DAVID STARR JORDAN
HIGH SCHOOL
STRUCTURAL STRENGTHENING
AND MODERNIZATION OF
AUDITORIUM AND BOILER HOUSE
2245 E. 103rd ST., LOS ANGELES, CAL.
STATE OF CALIFORNIA - DEPARTMENT OF GENERAL SERVICES
AS RE-DESIGNED FOR RECONSTRUCTION
25132 APPROVED NOV 20 1964

INDEX OF SHEETS, SCHEDULE AND MOSAIC PANEL DETAILS

DAVID STARR JORDAN
 HIGH SCHOOL
 STRUCTURAL STRENGTHENING
 AND MODERNIZATION OF
 AUDITORIUM AND BOILER HOUSE
 2265 E. 103RD ST., LOS ANGELES, CAL.
 STATE OF CALIFORNIA - DEPARTMENT OF GENERAL SERVICES
 DIVISION OF ARCHITECTURE AND CONSTRUCTION
 AS REVISED APR 13 1965
 25132 APPROVED NOV 20 1964
 APPLICATION NO. 100
 PER S. Morgan

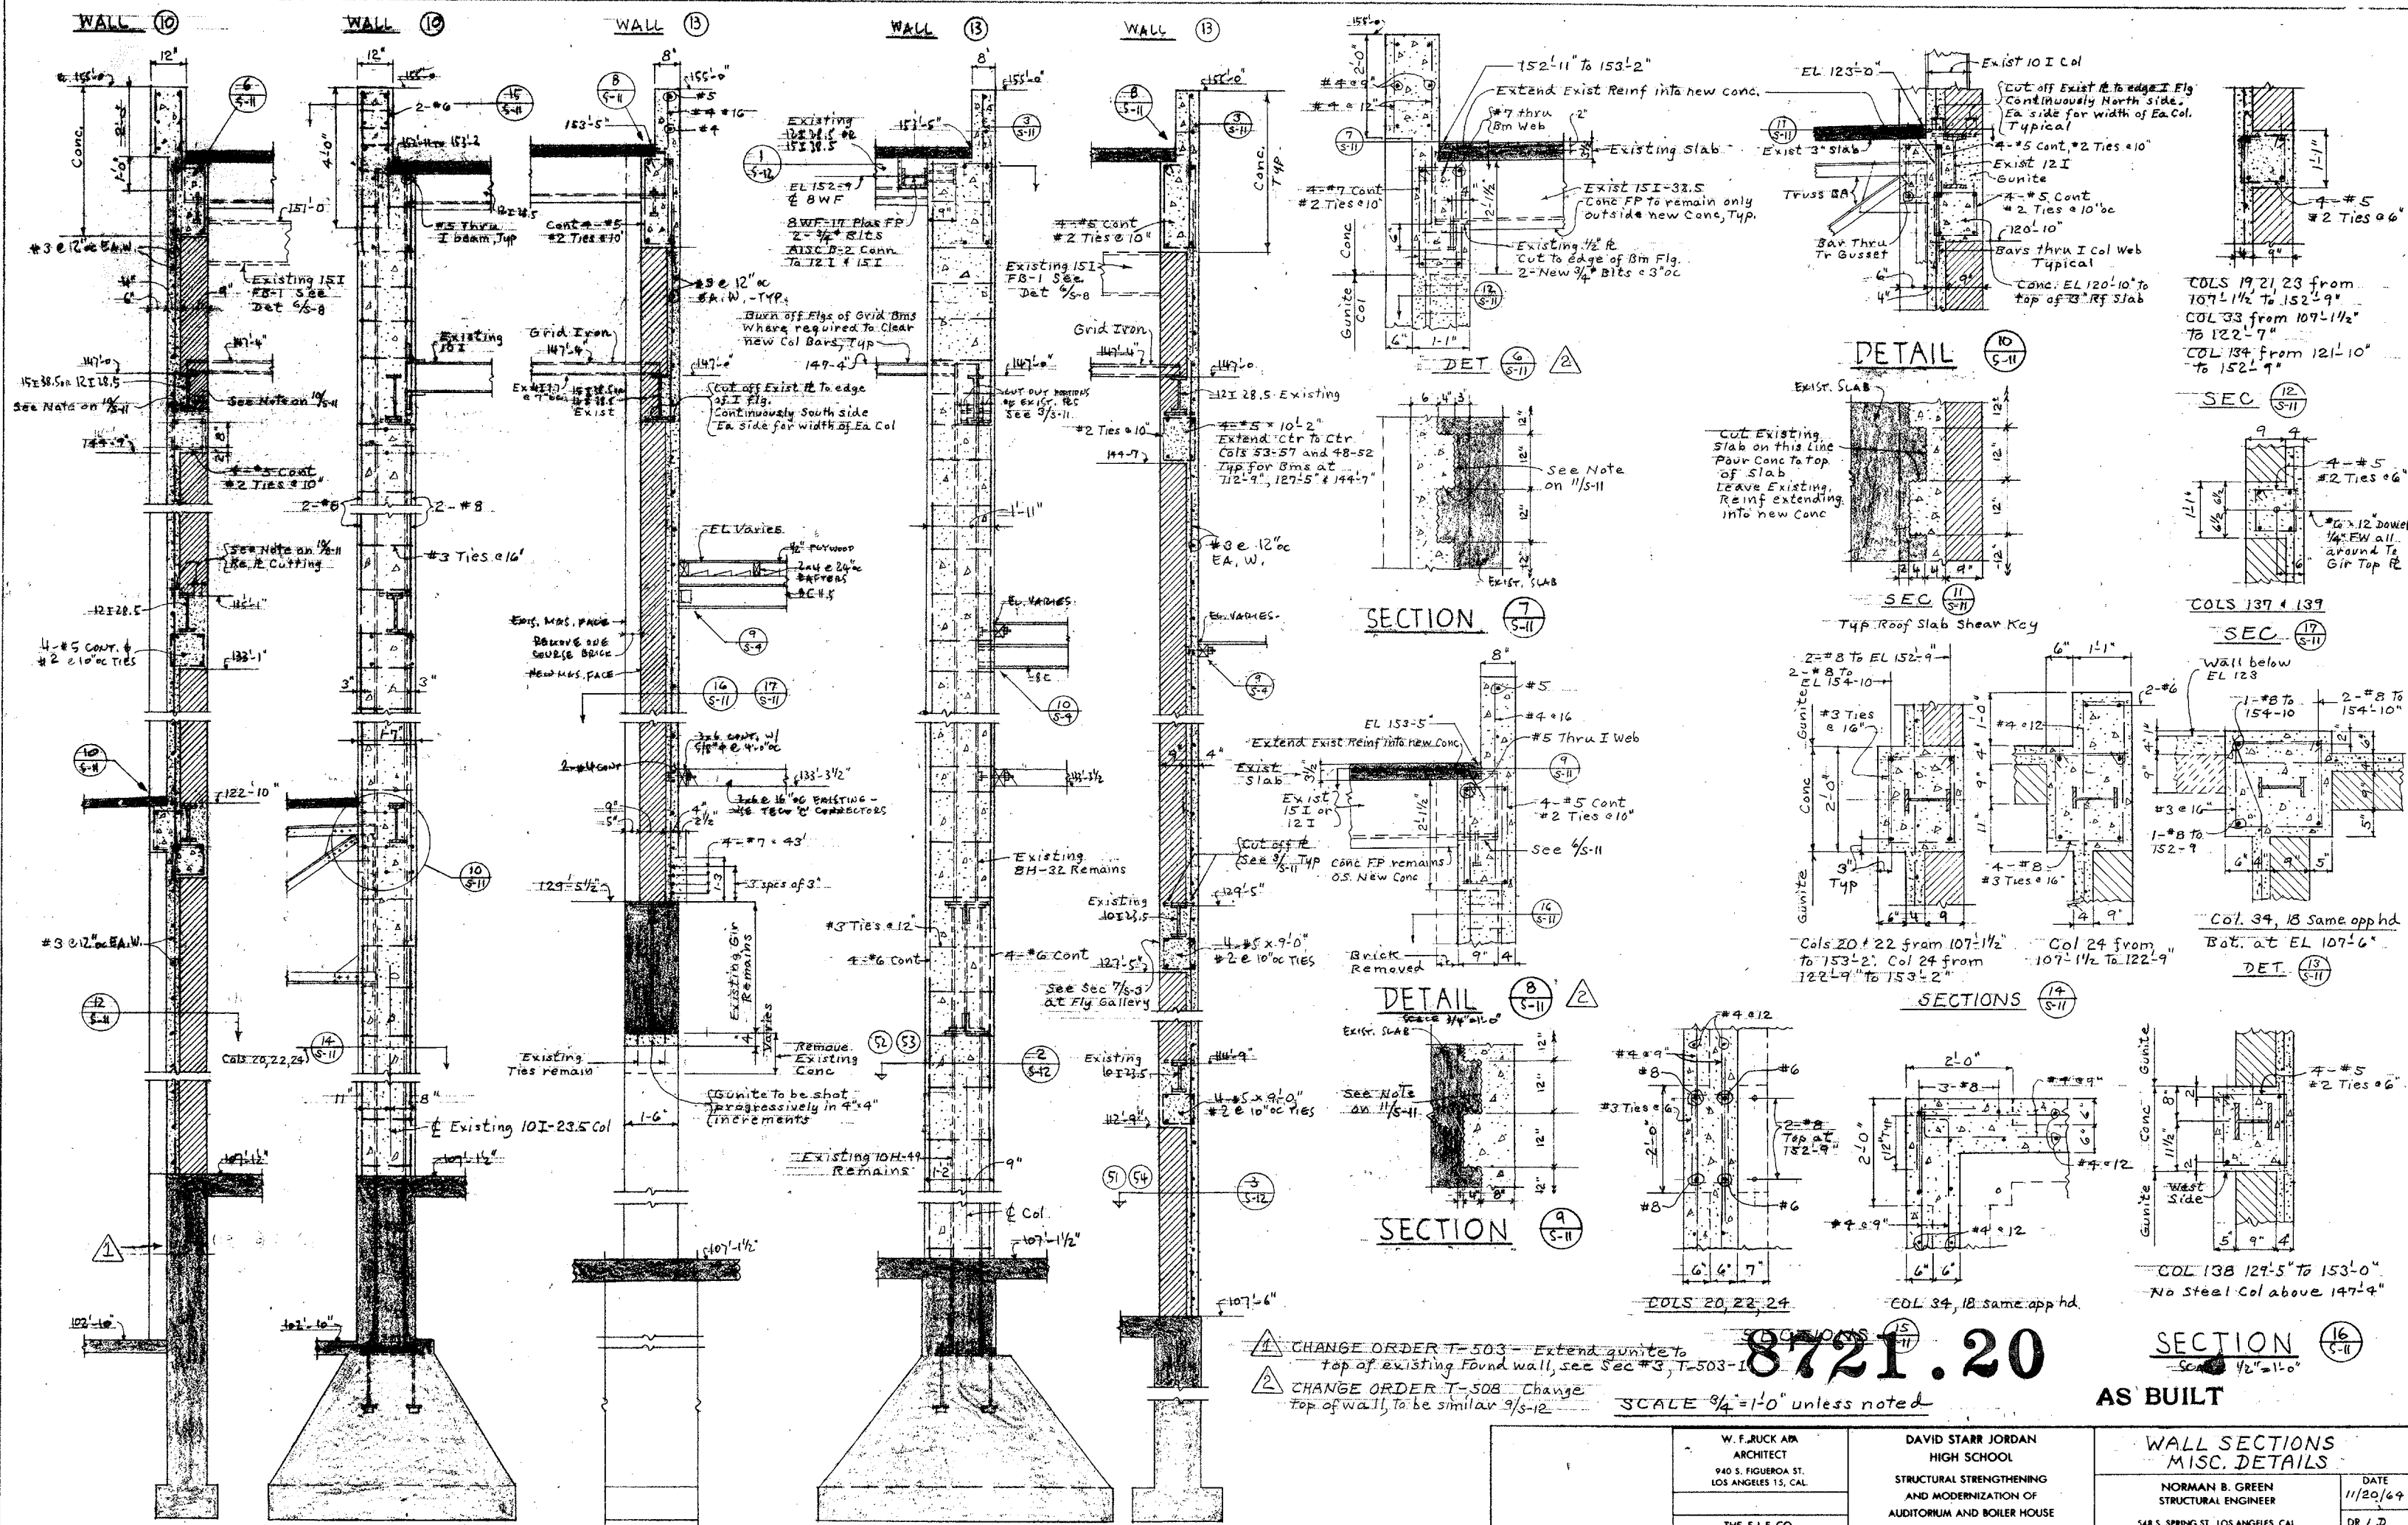
- 3 CHANGE ORDER T-514-Item #1 Provide splice scab similar to 1st at all rafter joints
- 4 CHANGE ORDER T-514-Item #2, Install new rafters to replace sub-standard rafters
- 5 CHANGE ORDER T-514-Item #3 Installation of a portion of 2x4 bldg. at purlin supports

CHANGE ORDER T-503 - Extend gunitite to top of existing found wall, see Sec #3, T-503-1

CHANGE ORDER T-508 - Change top of wall, to be similar 9/5-12

| | | | SHEET S-13 |

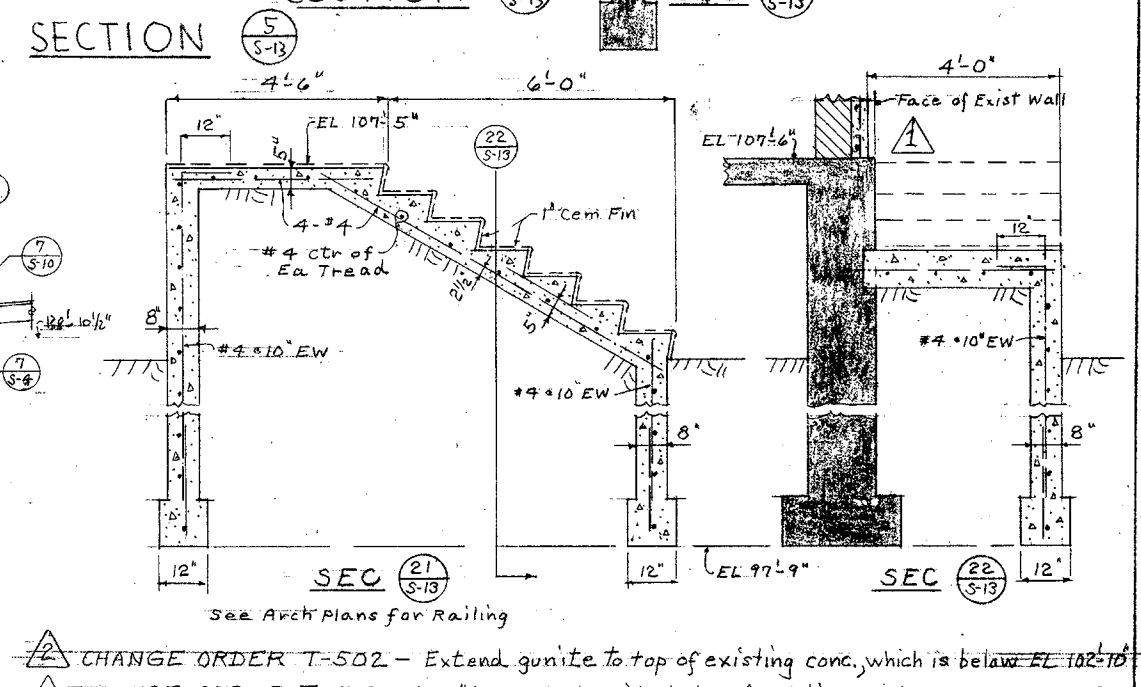
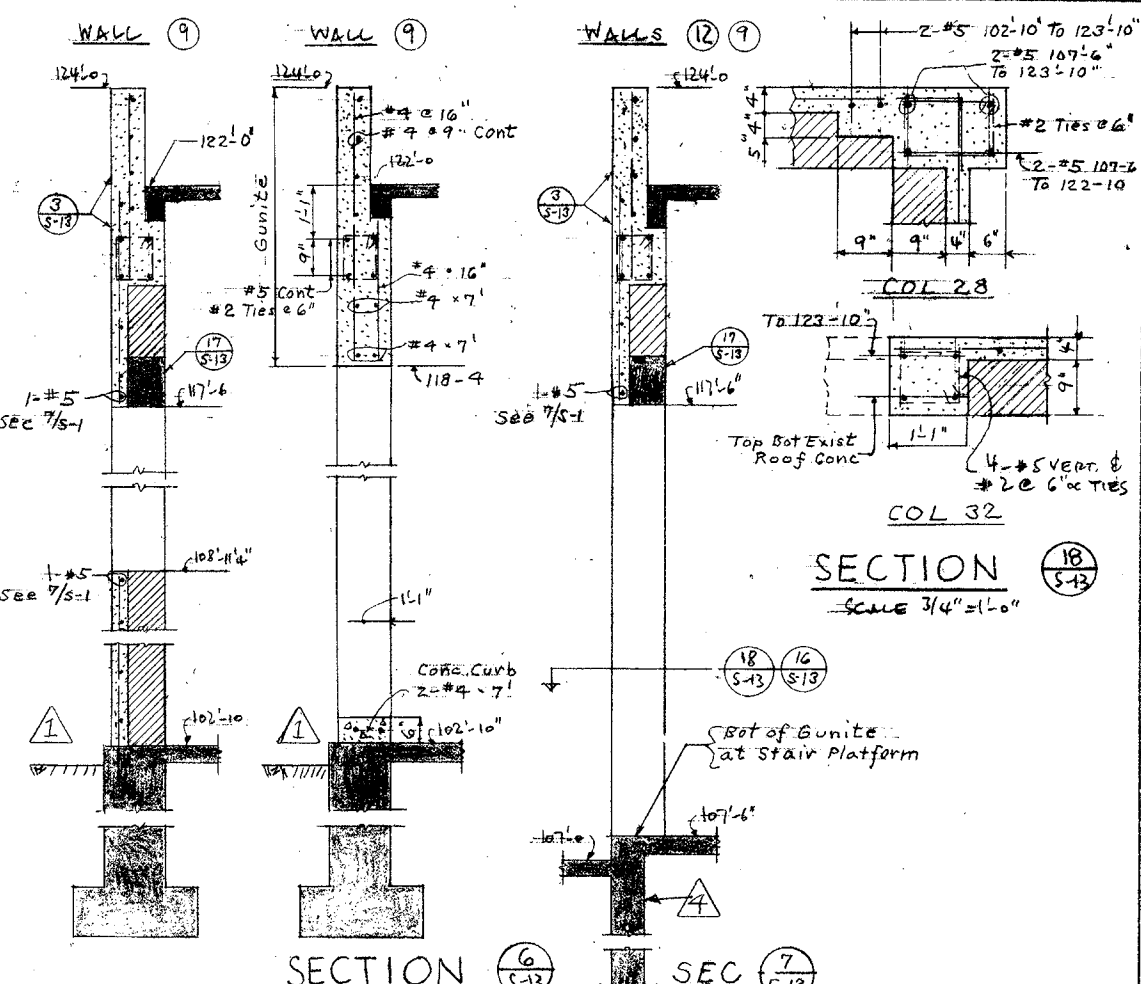
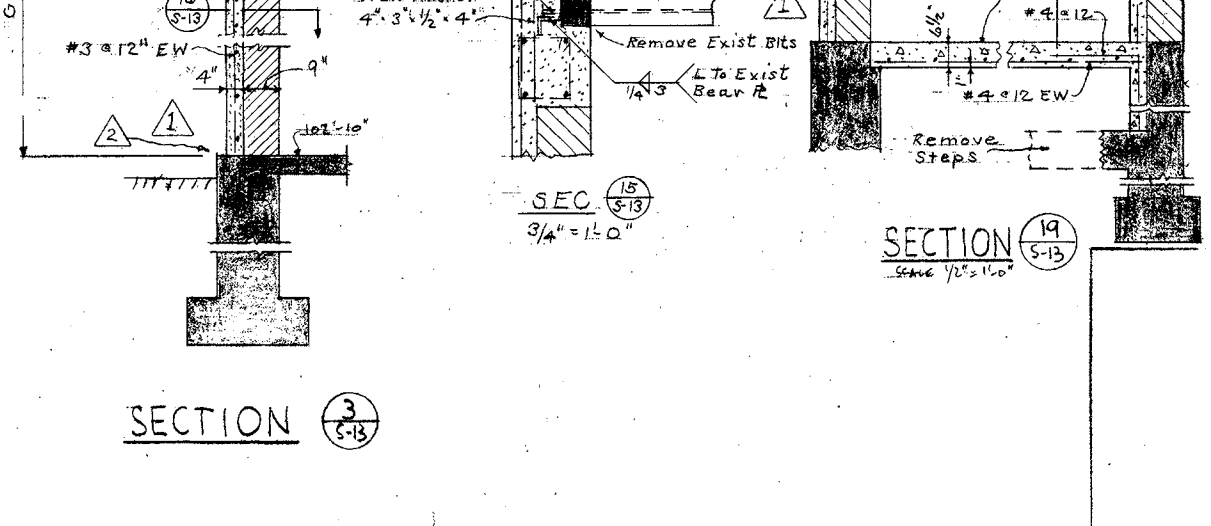
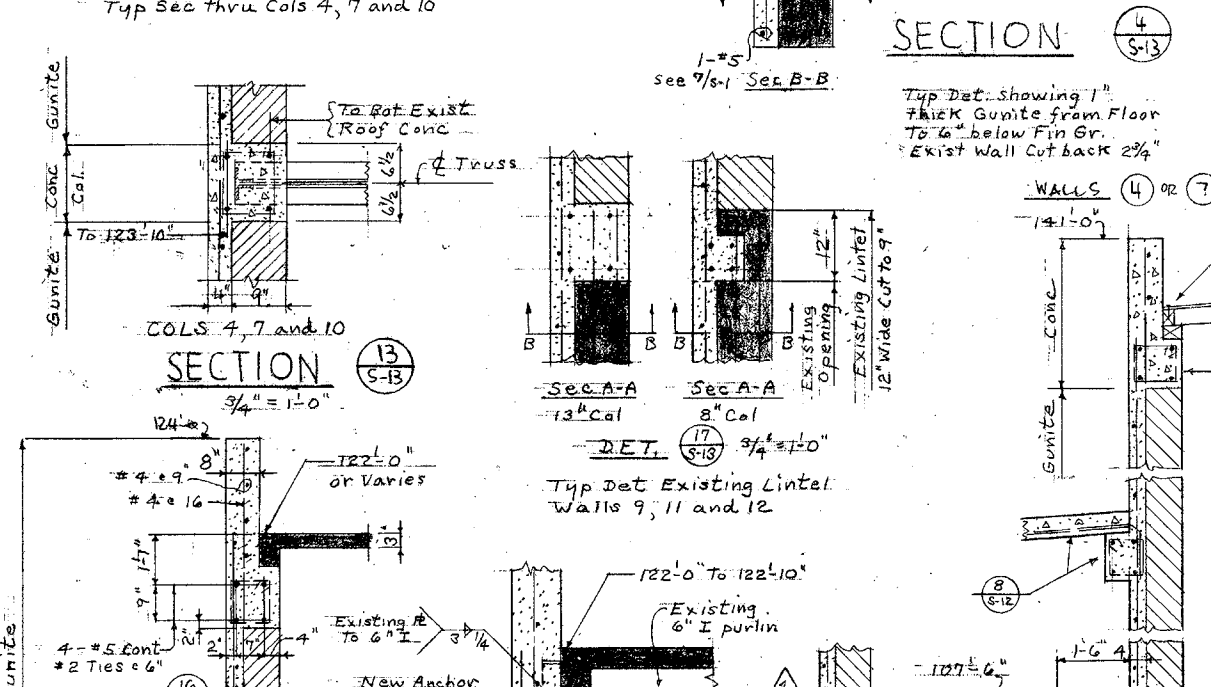
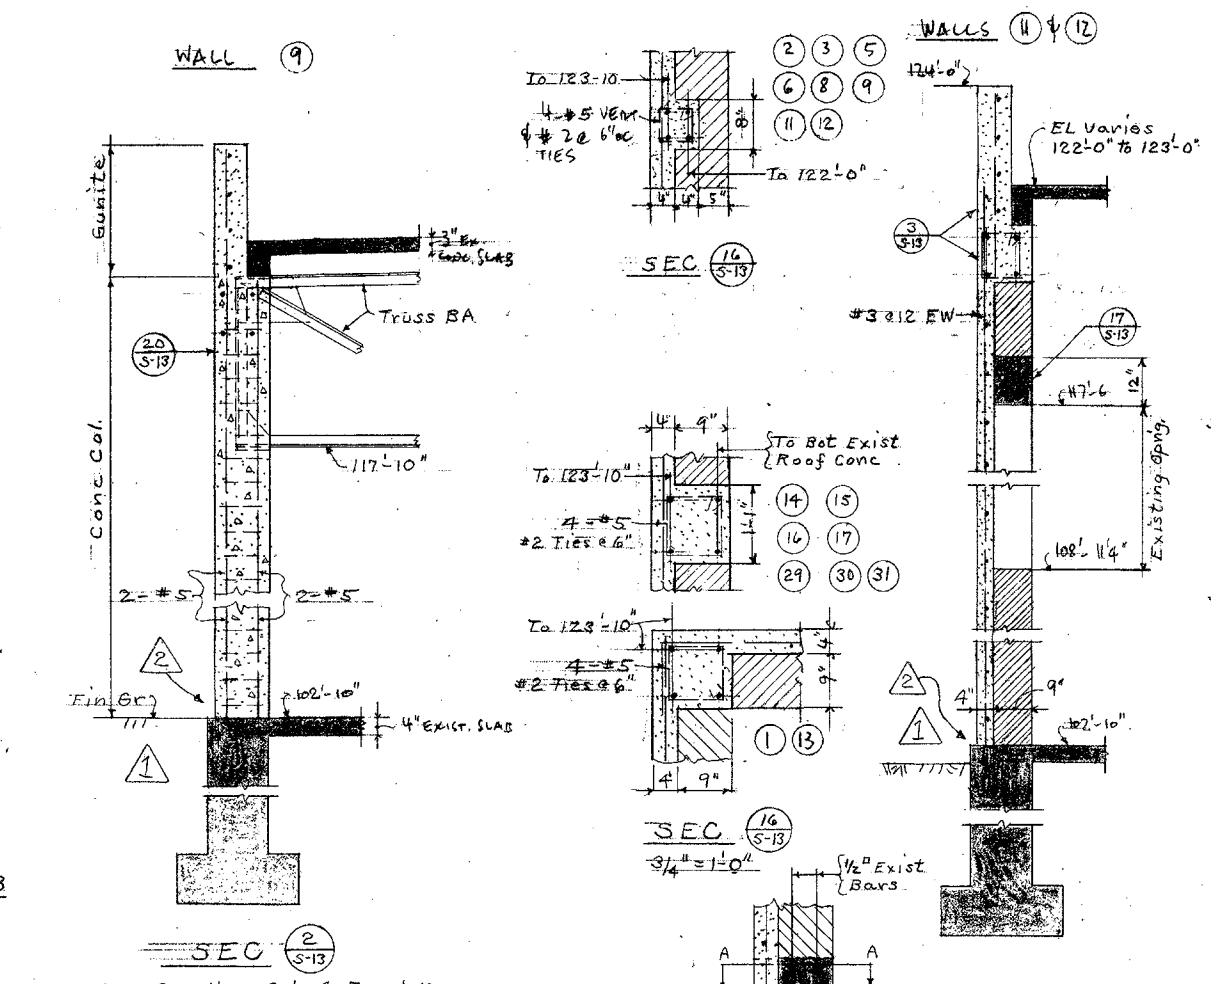
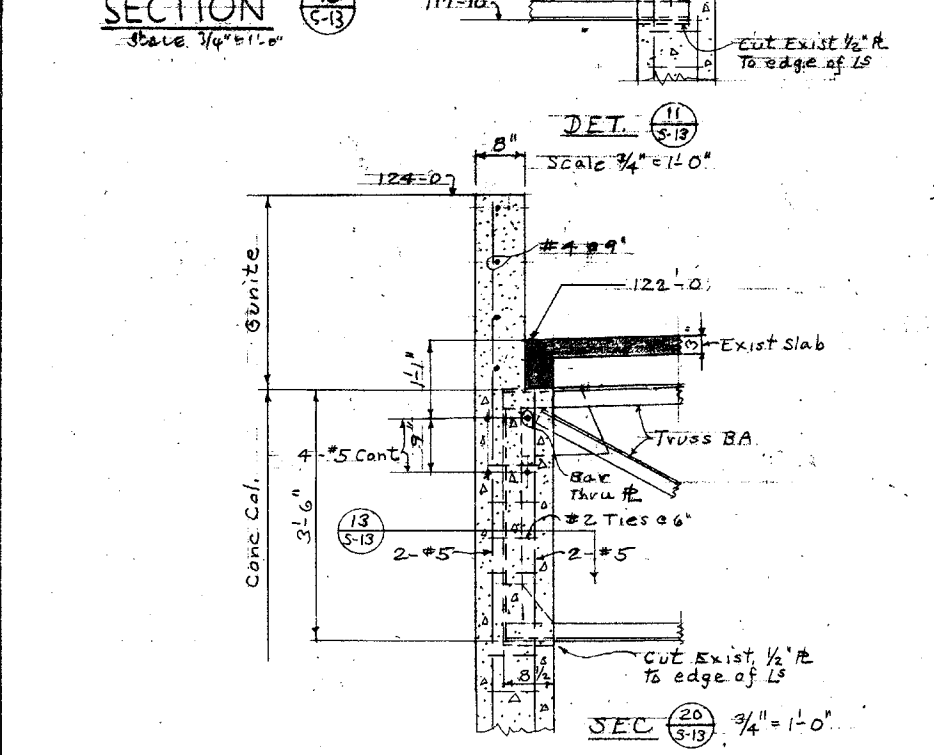
CHANGE ORDER T-502 - Extend gunite to top of existing conc, which is below EL 102'-10"

CHANGE ORDER T-503 - Item #1 - Extend gunite to top of existing Found walls, see Sec. 1

do do T-503 - Item #2 - Remove brick wall & provide new conc wall, see Sec. 2
